UNITED STATES PATENT AND TRADEMARK OFFICE

APPLICATION NO.	FILING DATE	FIRST NAMED INVENTOR	ATTORNEY DOCKET NO.	CONFIRMATION NO.
09/545,834	04/10/2000	Shuhei Harada	Q58793	3167

**Office Action Summary**

## **DETAILED ACTION**

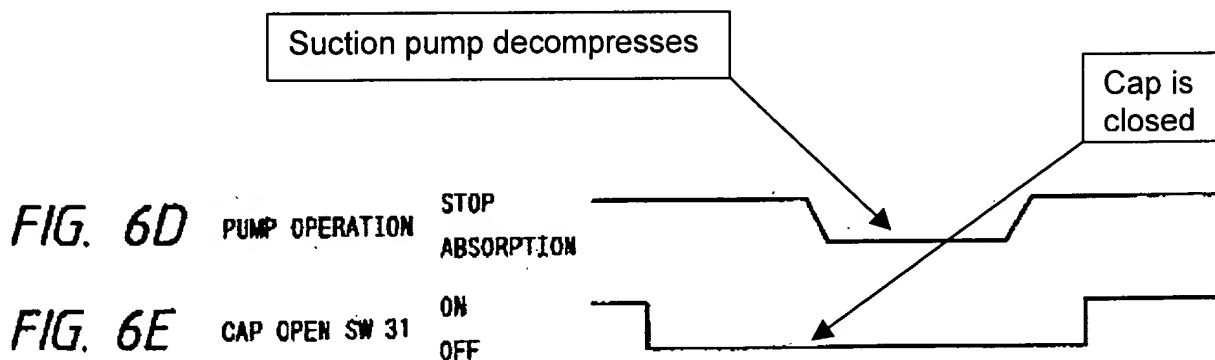
- A suction pump for reducing pressure (Fig.1: element 20);
- A control unit for controlling the valve unit, the capping unit and the suction pump unit (Fig1: element 56) such that suction pump decompresses the internal space of the capping unit under a condition that the valve unit closes the ink flow passage and the capping unit seals the nozzle orifice (Fig.8B-8D: shows at the first operation pump, the cap and the supply path are closed) the and the valve unit opens the ink flow passage after a first predetermined time period elapses (Column 6: line 3-19, Fig. 8E);

- The suction pump continues decompressing the internal space of the capping unit for a second predetermined time period (Fig.6C+6D);

- Wherein the controller controls the capping unit such that the decompressed stated of the internal space of the capping unit in maintained while the suction pump is driven (Fig.6D-6E)

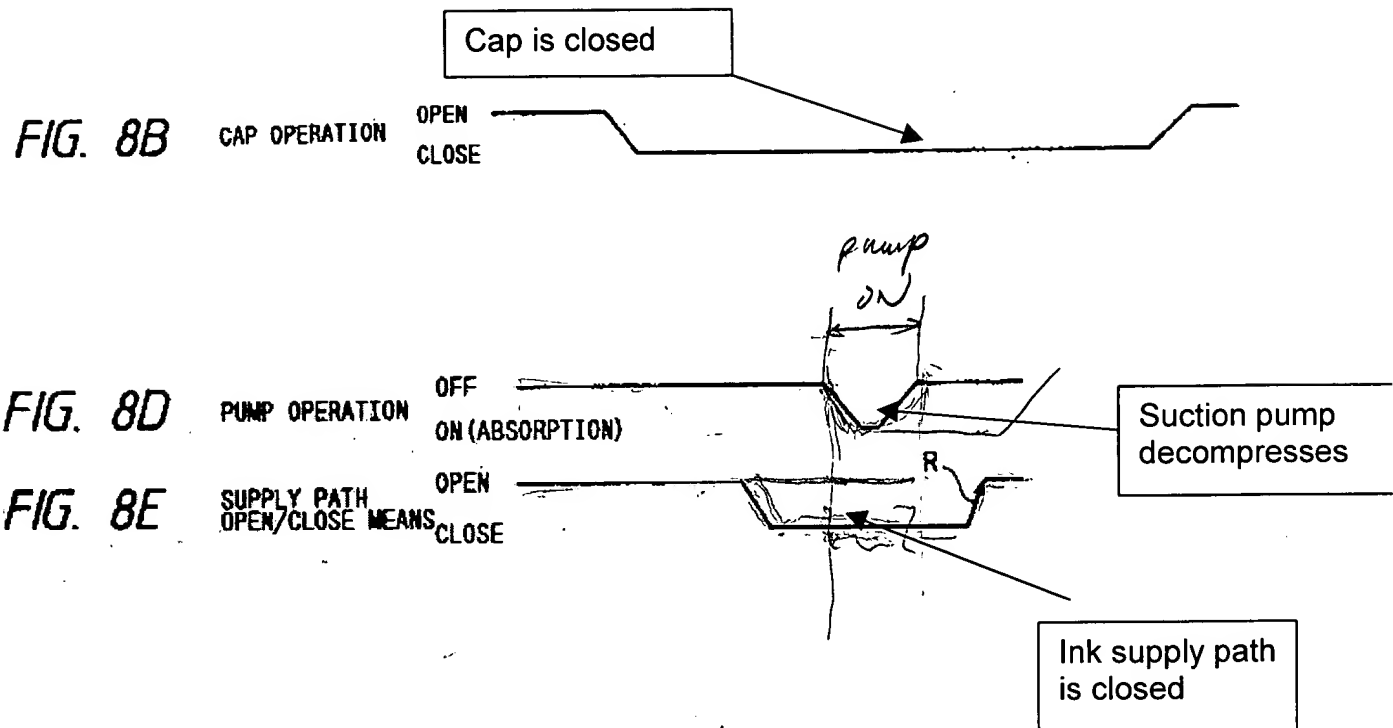
With respect to claim 70, Terasawa et al. discloses a control method wherein the sealing step and the closing step are executed synchronously (Column 6: line 3-6).

With respect to claim 71, Terasawa et al. discloses the step of stopping to drive the suction pump after a second predetermined time period has elapsed since the ink flow passage was opened (Fig.6C-6D).

With respect to claim 72, Terasawa et al. discloses the step of driving the suction pump between the sealing step and the closing step (Fig.6C-6E).

With respect to claim 73, Terasawa et al. discloses the step of driving the suction pump again after the stopping step has executed (Fig.6D).

With respect to claim 74, Terasawa et al. discloses step of releasing the capping unit from the nozzle orifices after the suction pump has driven again and driving the suction pump again to discharge ink from the nozzle orifices in a capping released state (Fig.6D-6E).

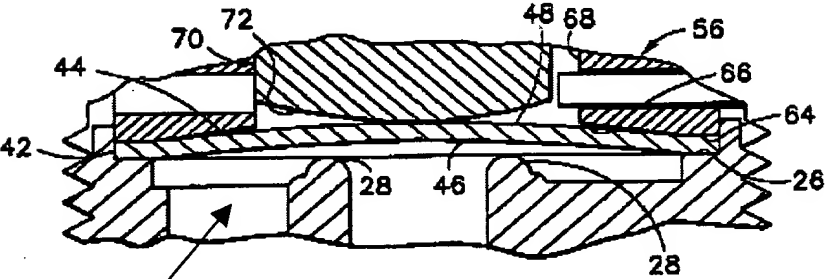
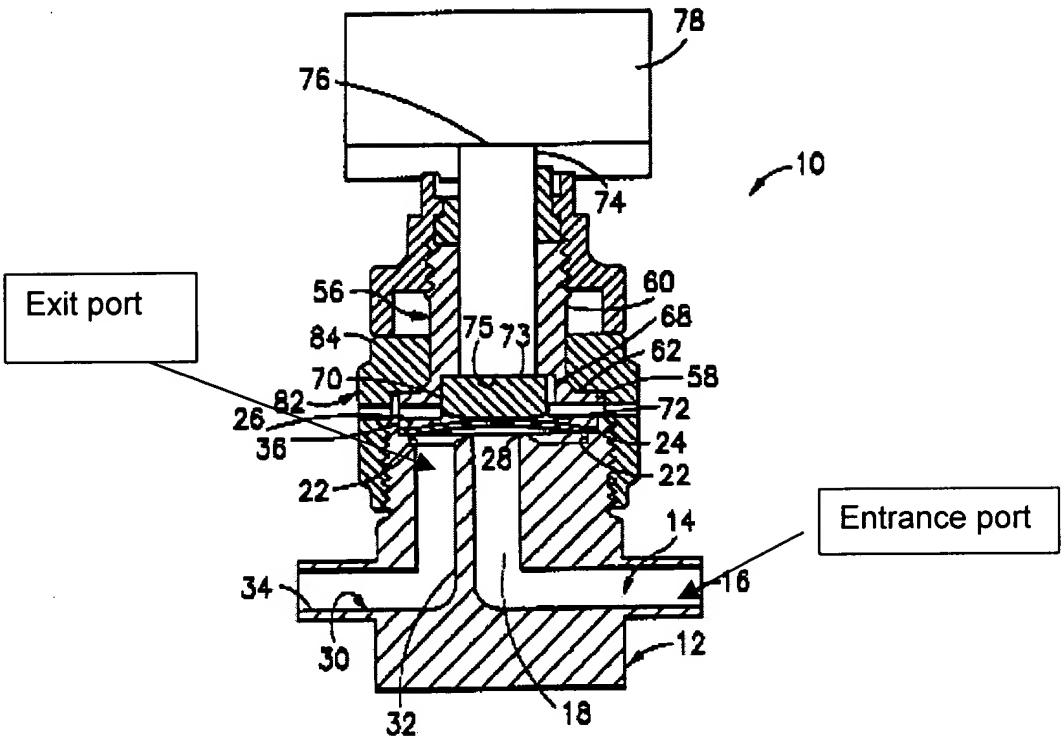
Terasawa et al. teaches an apparatus of a valve unit for opening/closing.

However, Terasawa et al. fails to teach a valve control chamber, a flexible diaphragm, an actuation body, valve control chamber has an entrance port formed on a top wall thereof at a portion where is away from the center portion of the diaphragm and an exit port formed on the top wall, the entrance port is arranged below the exit port, the circumferential portion of the exit port is tapered, the diaphragm includes an annular convex portion and the actuation body is a rod member.

Wu et al. teaches a valve control chamber (fig.1: element 20), a flexible diaphragm (Fig.3: element 40), an actuation body (Fig.1: element 74+78), valve control chamber has an entrance port formed on a top wall thereof at a portion where is away from the center portion of the diaphragm and an exit port formed on the top wall (Fig.1), the entrance port is arranged below the exit port (Fig.1), the circumferential portion of the exit port is tapered (Fig. 2), the diaphragm includes an annular convex portion (Fig. 2: element 48) and the actuation body is a rod member (Fig. 1: element 70+74).

It would have been obvious to one having ordinary skill in the art to have a valve control chamber, a flexible diaphragm, an actuation body the diaphragm includes an annular convex portion as taught by Wu et al in the invention of Terasawa et al. The motivation of doing so in order to achieves affective sealing of high-pressure gas (Wu et al., Column 3: line 37-55)

Exit port is tapered (larger on the top and smaller on the bottom)
